ANCHOR BOLT SETTING PLAN
(BOTTOM OF BASE PLATE ELEVATION: (-1'-10") (U.N.O)
(REF:S1.1)

07/24/2020			ISSUE FOR APPROVAL
DATE	NO.		DESCRIPTION
REVISIONS

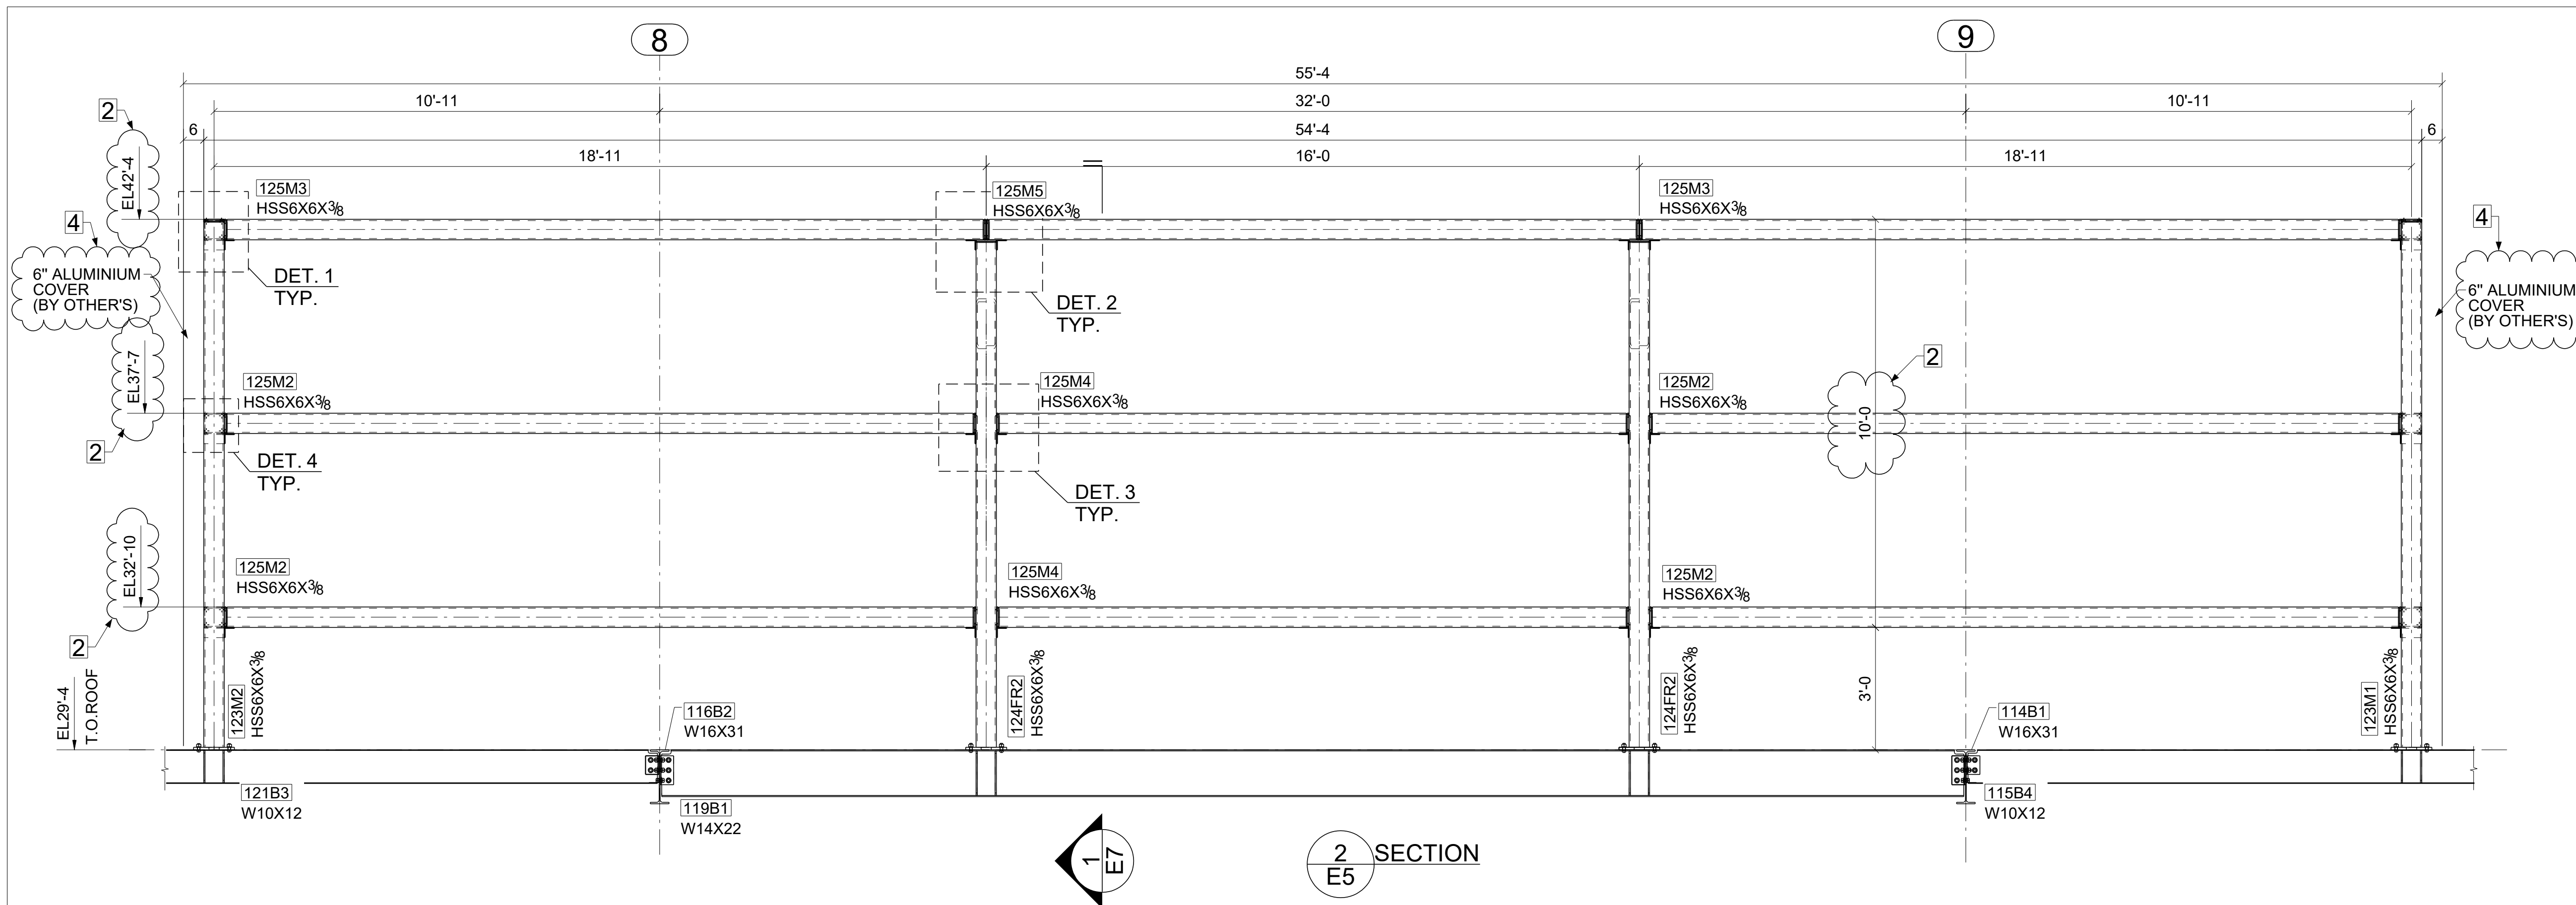
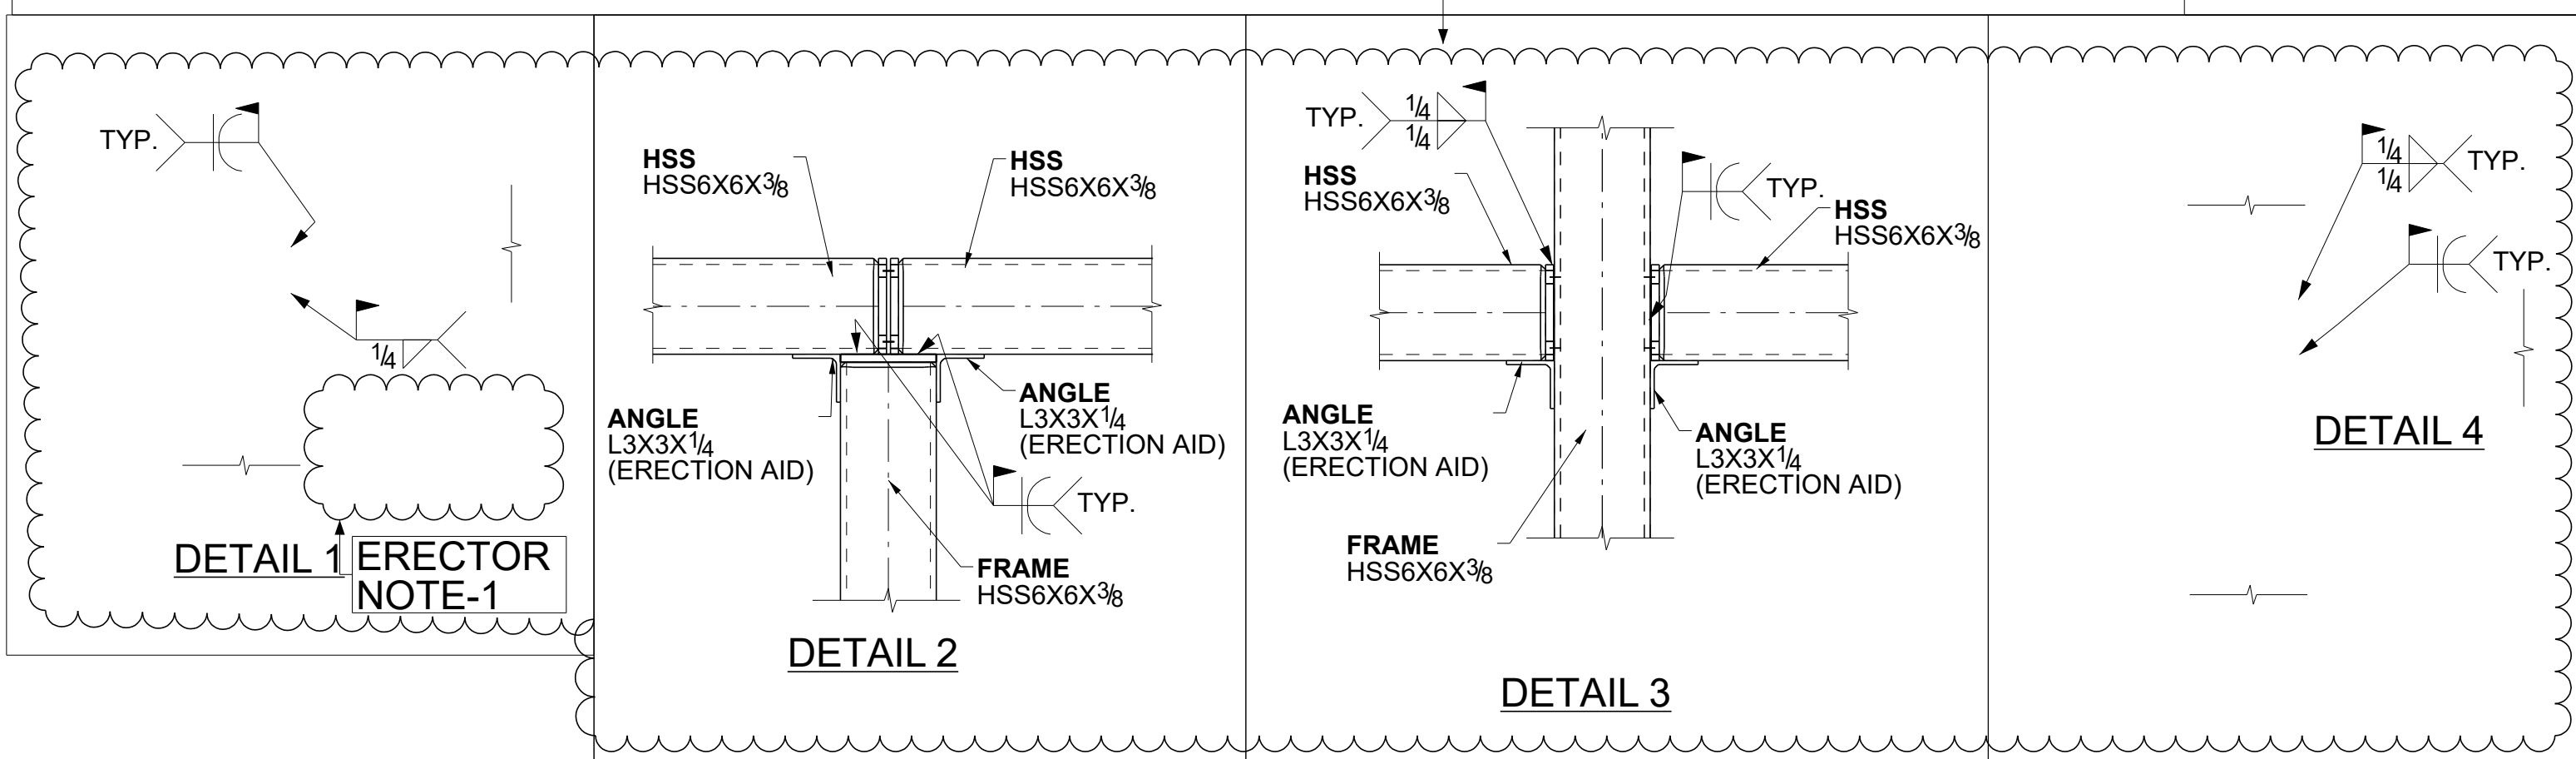
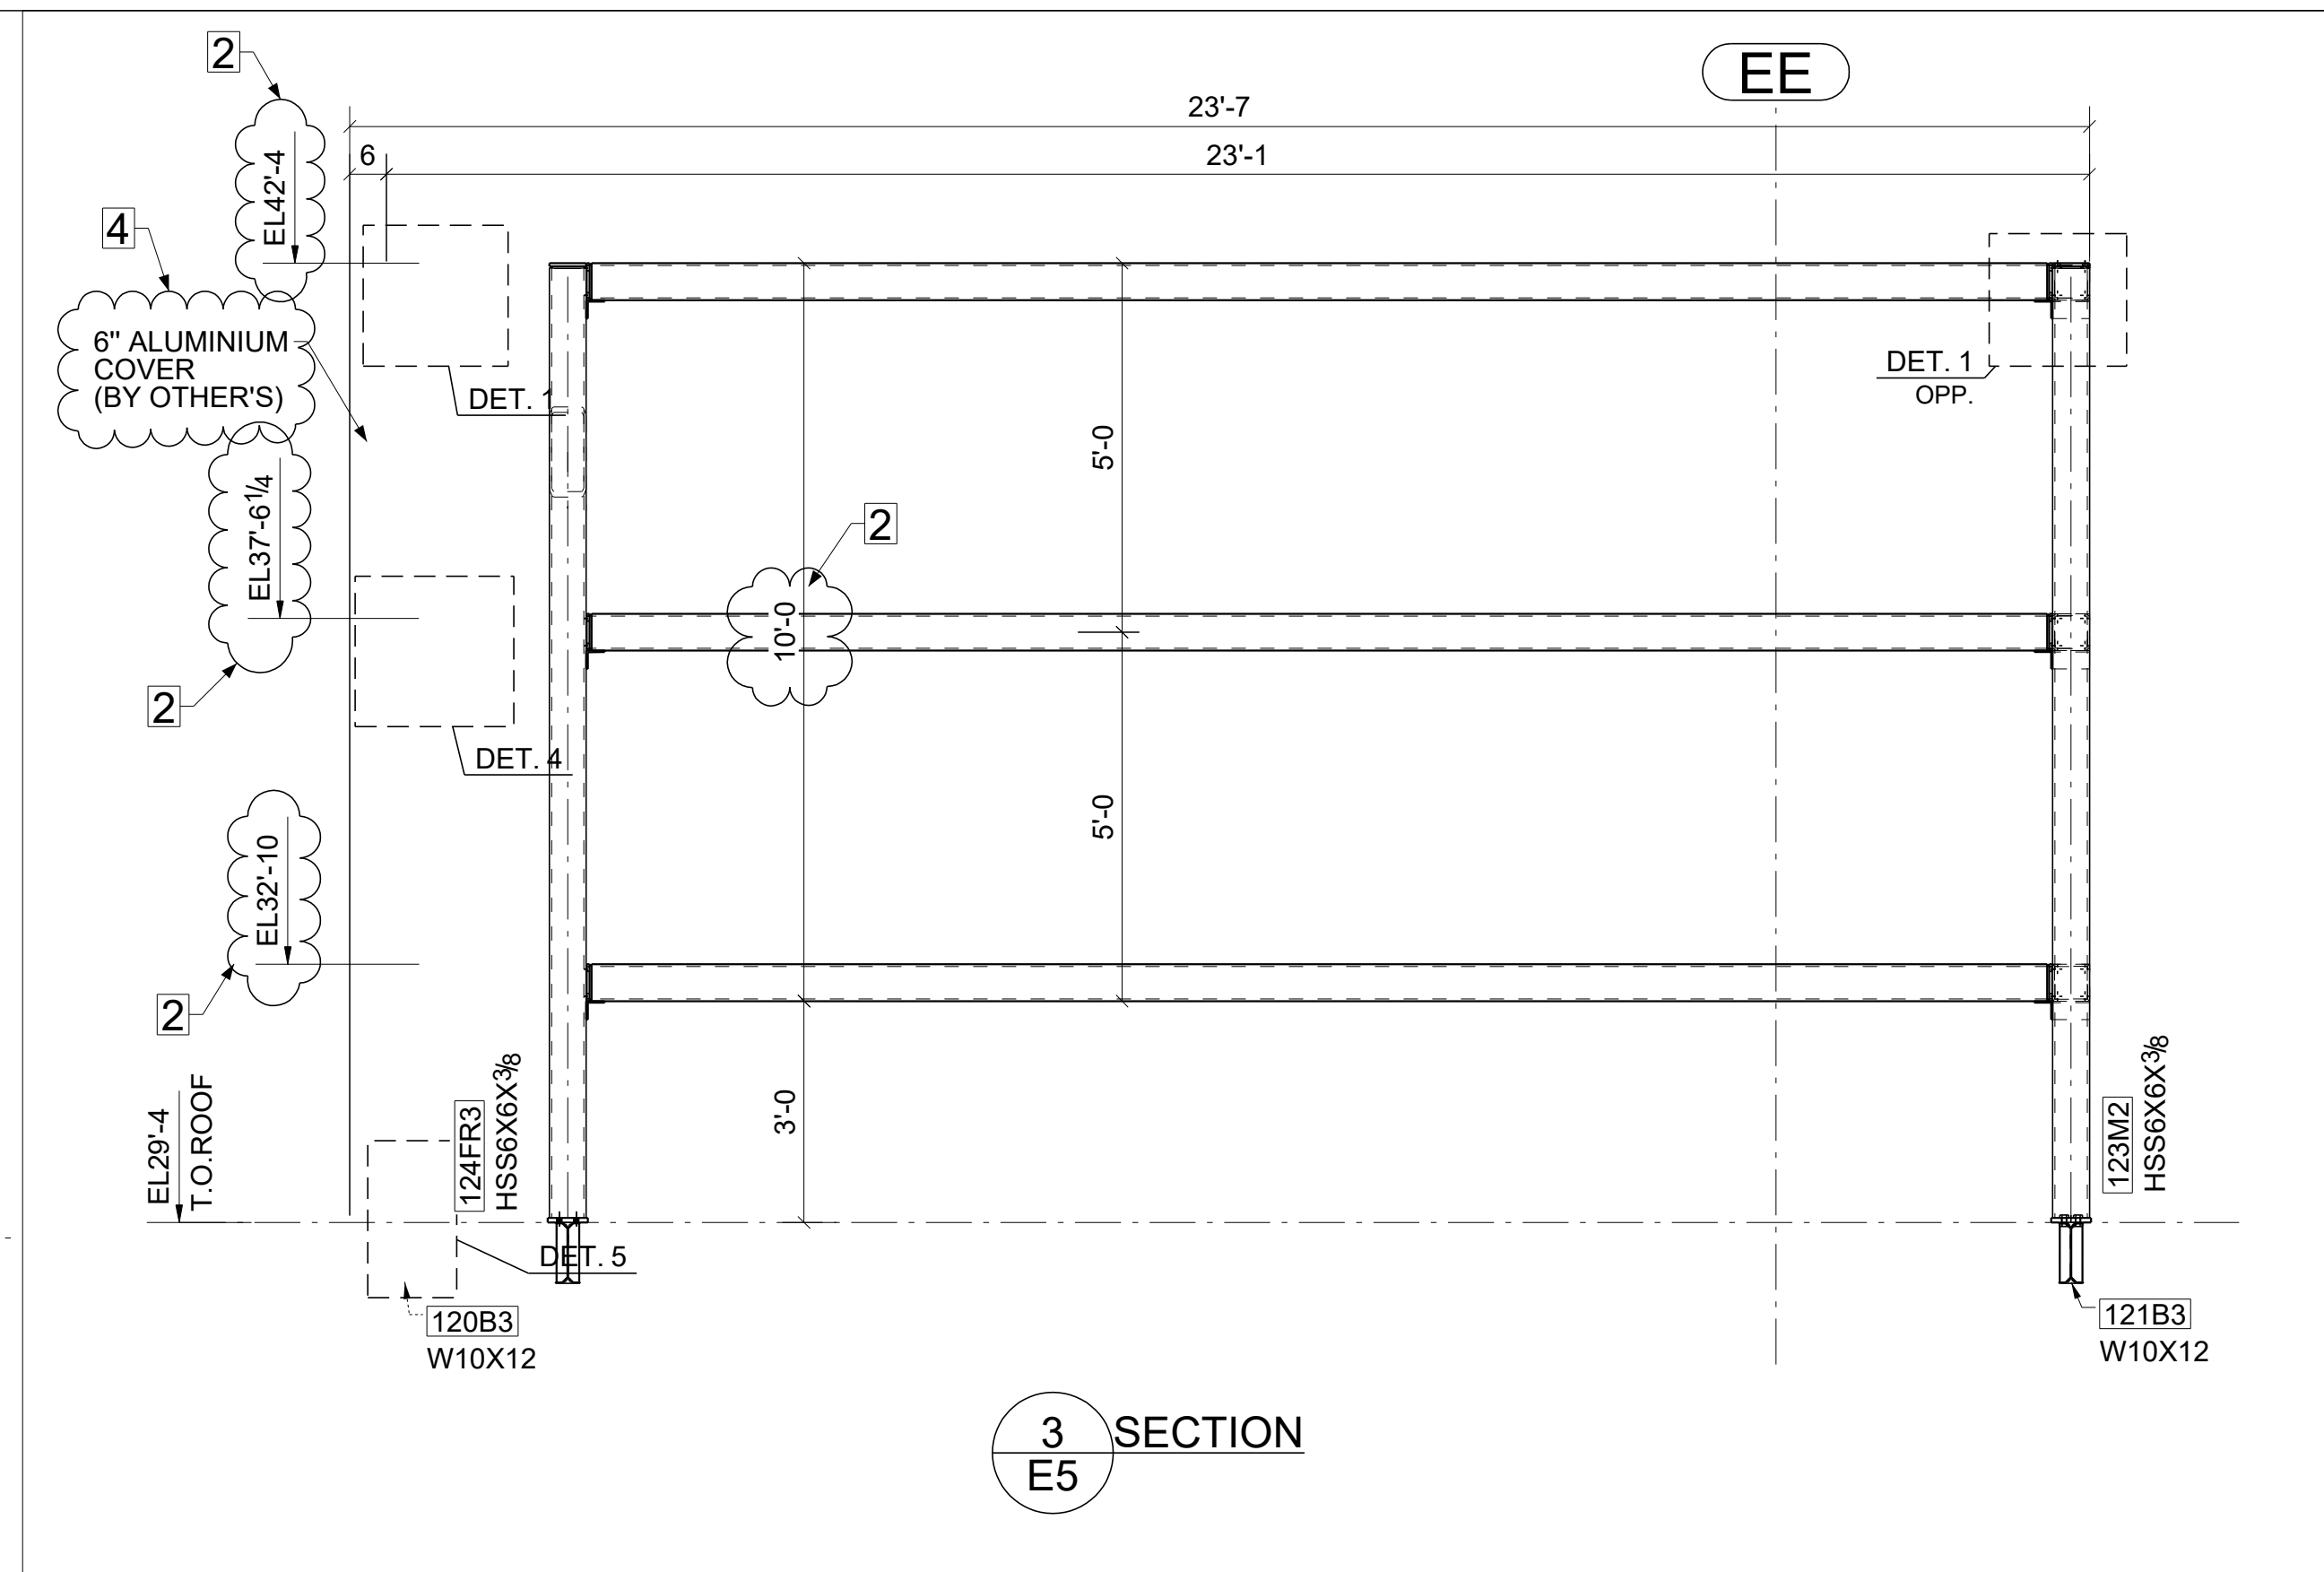
- PLEASE REVIEW AND CONFIRM THE CLOUDED ROOF SCREEN WALL SUPPOT STEEL CONNECTIONS FOLLOWED
- THE CLOUDED 10'-0" DIMENSION (PER STRUCTURAL) IS SHOWN AS 9'-0" IN ARCH DRAWINGS . ALSO IT IS INDICATED IN ARCH TO MATCH THE HEIGHT OF ROOF SCREEN WALL WITH EXISTING ROOF SCREEN WALL. HENCE PLEASE REVIEW AND CONFIRM THE CLOUDED DIMENSION AND ELEVATIONS OF ROOF SCREEN WALL.
- AT POSTS SEATING CONNECTION, WE ARE PROVIDING $\frac{3}{8}$ " THINK STIFFENER PLATES IN BEAMS TO ALIGN THETHE HSS FACES AS CLOUDED. PLEASE REVIEW & CONFIRM.
- FROM ARCHITECTURAL DRAWINGS, WE ARE ASSUMING THAT THERE 6" ALUMINIUM COVER TO THREE SIDES OF ROOF SCREEN WALL WHICH INCLUDED IN THE 55'-4" & 23'-7" ROOF SCREEN WALL DIMENSION SHOWN IN A.I.S.O. PLEASE REVIEW AND CONFIRM.
